Access Compliance Report Public Rights-of-Way (Curb Ramps)

Main Street: FAIRHAVEN_AVE		Cross Street: DUNAS_RD		Location:	NW
ADA ID: RPAT211022094710	Ramp Type: Type 3 - Combination 1	Initial Pass/Fail: Fail	Overall Compliance: No	Severity Score:	2
Codes/Mitigation Info/Possible Solution			Field Measurements/Component Compliance

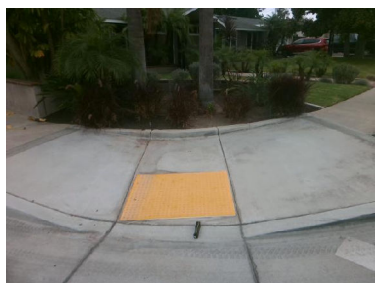
Compliance	Description	Data	Compliance	Description	Data
N/A	Ramp Length LT (in)	93	N/A	Ramp Length RT (in)	93
Yes	Ramp Width LT (in)	93	Yes	Ramp Width RT (in)	105
Yes	Ramp Run Slope LT (%)	6.5	Yes	Ramp Run Slope RT (%)	8.2
No	Ramp Cross Slope LT (%)	4.6	No	Ramp Cross Slope RT (%)	3.8
N/A	Ramp Length (in)	48	N/A	Flare Type LT	
Yes	Ramp Width (in)	48			N/A
Yes	Ramp Run Slope (%)	7.3	N/A	Flare Slope LT (%)	N/A
No	Ramp Cross Slope (%)	4.1	N/A	Flare Traversable LT	N/A
N/A	Landing Present	N/A	N/A	Flare Type RT	
N/A	Landing Length (in)	N/A			N/A
N/A	Landing Width (in)	N/A	N/A	Flare Slope RT (%)	N/A
N/A	Landing Run Slope (%)	N/A	N/A	Flare Traversable RT	N/A
N/A	Landing Cross Slope (%)	N/A	N/A	DWS Provided	N/A
N/A	Landing Movement Obstructed?	N/A	N/A	DWS Contrast	N/A
	Landing Movement Type	N/A	N/A	DWS Length (in)	N/A
N/A	Landing Shared	N/A	N/A	DWS Full Width	N/A
N/A	Clear Space	Yes		DWS Offset Type	N/A
N/A	Clear Space To Crosswalk (in)	N/A	N/A	DWS Offset Left (in)	N/A

Remove & Replace Curb Ramp With Two New Directional Ramps or Equivalent.

R304.2.2, R204.3, R304.5.3, STD 1115
